Norfolk Vanguard Offshore Wind Farm

Written summary of the Applicant's oral case at Issue Specific Hearing 2

Offshore Environmental Matters

Applicant: Norfolk Vanguard Limited
Document Reference: ExA; ISH; 10.D3.2
Deadline 3

Figure 1 *Sabellaria spinulosa* reef mapping by the Applicant and Natural England

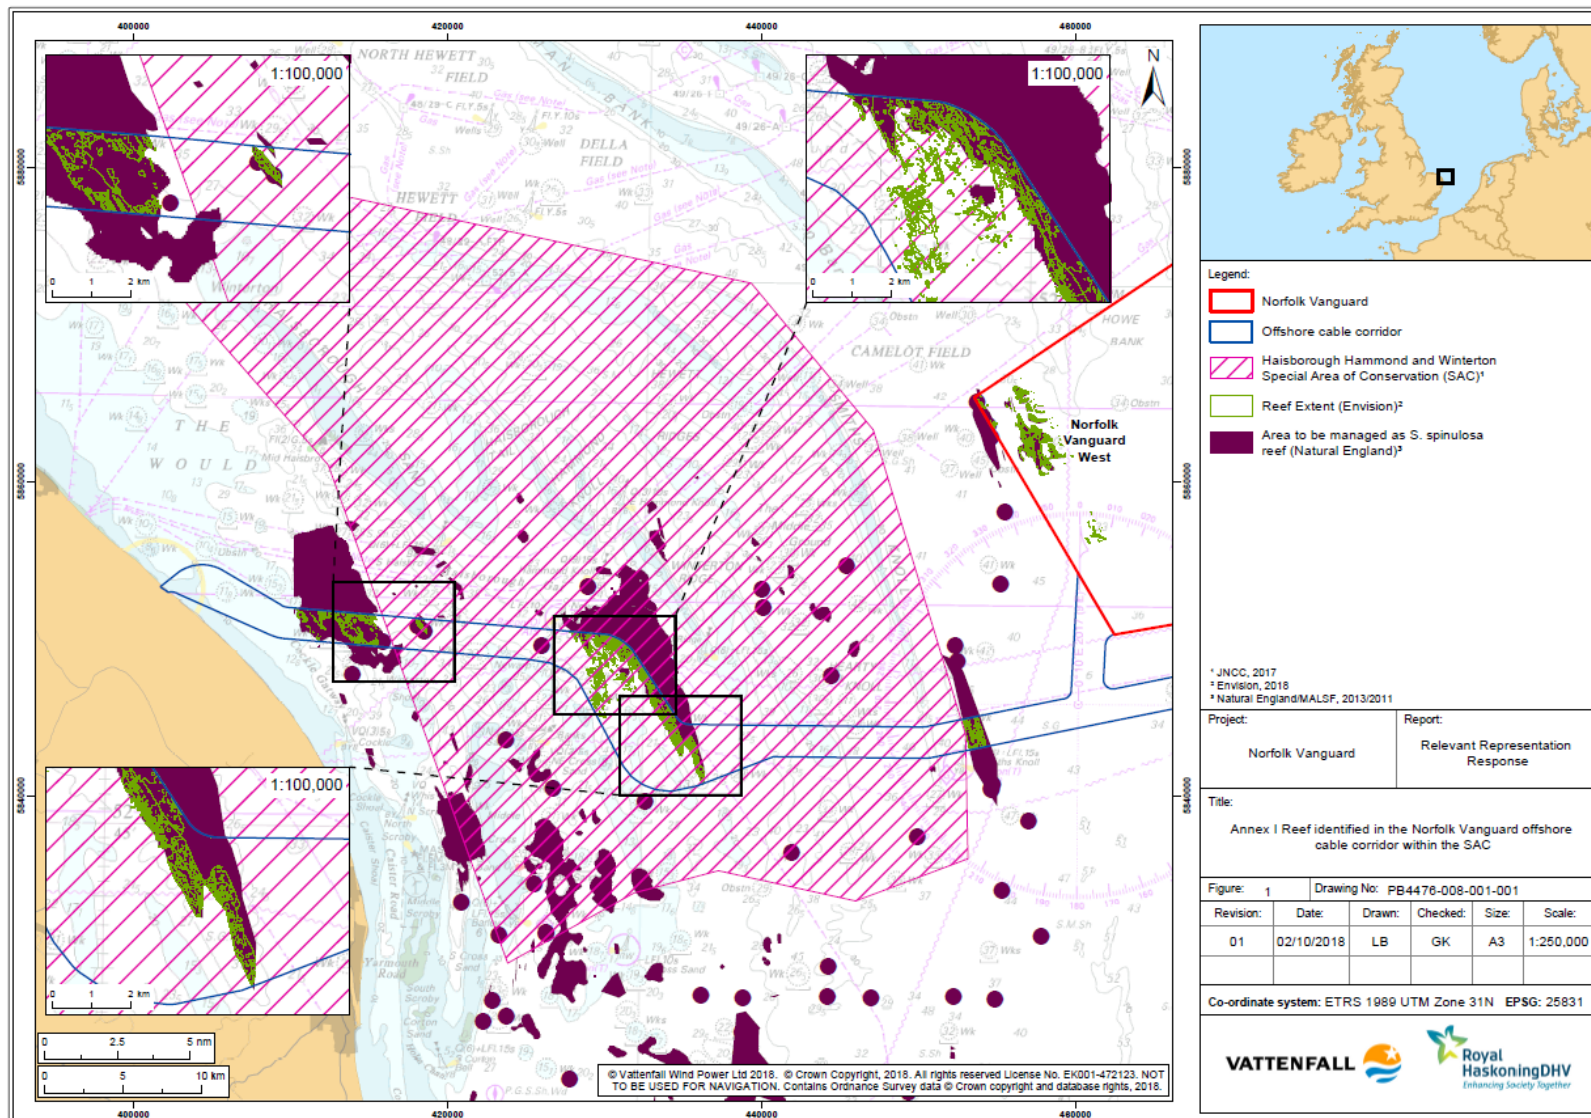
- 4.10 Annex C of Natural England's Deadline 1 submission (paragraph 3.1.1) refers to "*flawed methods used for assessment*" and states as a result of this "*Natural England cannot currently provide an evidence based opinion on the actual scale of impacts*". The Applicant discussed this statement with Natural England on a call on 22nd January, and Natural England confirmed that this comment refers to the *S. spinulosa* reef mapping approach.

- 4.11 As stated in Appendix 1 of the Applicant's Deadline 2 submission³, and as also shown in the Statement of Common Ground (SOCG) with Natural England submitted at Deadline 1 (document reference Rep1-SOCG-13.1), irrespective of the methodology used the Applicant and Natural England agree on the general extent and location of *S. spinulosa* reef. The outputs of the Envision mapping correlate closely with maps produced by Natural England which identify areas to be managed as *S. spinulosa* reef, as shown in Figure 1.

- 4.13 During the conference call with Natural England on 22 January, in response to the Applicant's position that the focus should be on the commitment to determining actual reef presence and extent prior to construction, Natural England felt it was important for Natural England to note any disagreement of the mapping method only to avoid setting a precedent. On this basis, the Applicant suggests this should not remain a key issue for the examination and will seek to agree this with Natural England through the SOCG. In terms of not setting a precedent, the Applicant notes that the methodology Natural England has used to determine *S. spinulosa* reef extent in the SAC is unclear and would welcome further details on this.

- 4.12 The Applicant has recognised and assessed the potential that the location and extent of *Sabellaria* reef is subject to change, as the species is ephemeral in nature and therefore the extent at the time of construction is unknown. The Applicant suggests that this ephemeral characteristic is the key limitation with regards to Natural England providing an evidence-based opinion on the actual scale of the potential impacts to *S. spinulosa* reef and as such, the Applicant has committed to undertaking pre-construction surveys (as required by dDCO Schedules 11 and 12 Part 4 Condition 13(2)(a)) and to agree cable installation methods and routing with the MMO through the Construction Method Statement (required under dDCO, Schedules 11 and 12, Part 4 Condition 9(1)(c)) and Cable Specification Installation and Monitoring Plan (required under dDCO Schedules 11 and 12, Part 4 Condition 9(1)(g)).
